**To:** John Robison, Public Lands Director, Idaho Conservation League; Pete Dronkers, Southwest Circuit Rider, Earthworks; and Judy Anderson, private citizen  
**From:** Ann Maest, PhD; Buka Environmental  
**Date:** 28 October 2020  
**Re:** Additional comment on the Stibnite Gold Project, Idaho: PHREEQC modeling of groundwater under Development Rock Storage Facilities

### Additional Comment on PHREEQC Modeling

**Figure 1. Predicted antimony concentrations in groundwater under the Hangar Flats DRSF over time.** The dashed red line is the groundwater quality standard of 6 µg/L (DEIS, Table 3.9-2, p. 3.9-15).

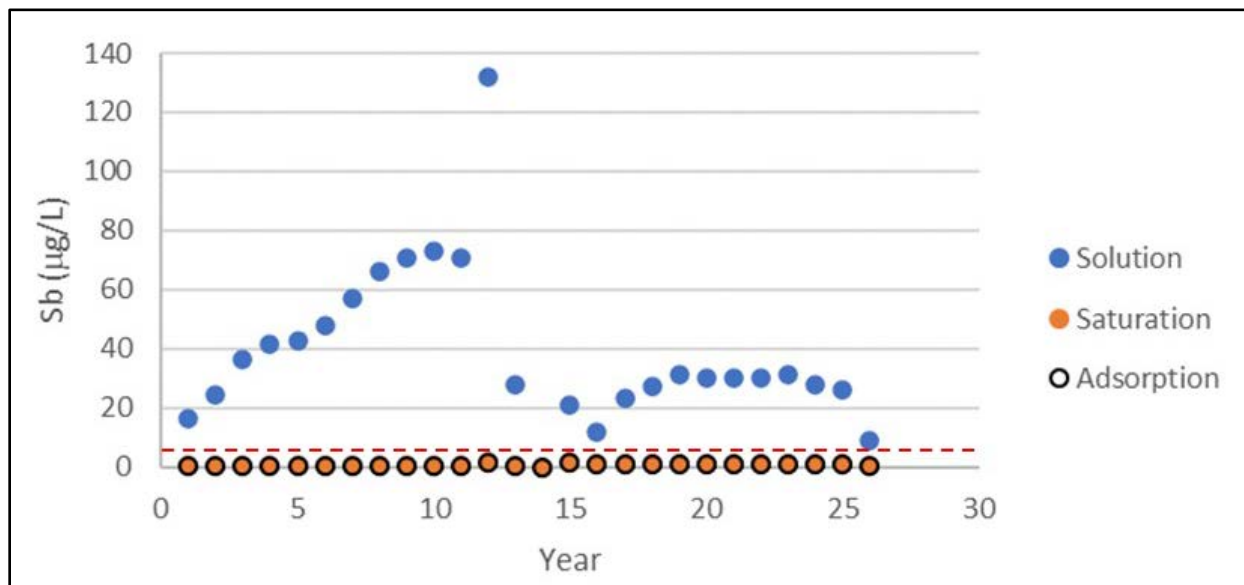
Running the input file in PHREEQC with the selections in the input file creates a separate file with the predicted results. Using the results for predicted antimony concentrations without modification, with the assumption of saturation with  $\text{SbO}_2$ , and with adsorption, I created Figure 1. The figure shows that without the forced solubility control for antimony, predicted concentrations under the DRSF would exceed the groundwater standard for all years under all conditions. Predicted results assuming saturation with  $\text{SbO}_2$  and with adsorption are similar -

both sets of results show that the predicted antimony concentrations in groundwater would never exceed the relevant groundwater standard.

The results demonstrate the uncertainty of the predictions and the influence of incorrect conceptual models – in this case, the assumption of equilibrium with an antimony phase that does not exist. A revised DEIS should present the results of the geochemical modeling efforts and use a range of predicted concentrations that would feed into the site-wide water chemistry (SWWC) model. If this were done, it is likely that some of the predicted water quality in surface water and groundwater would exceed relevant water quality standards.
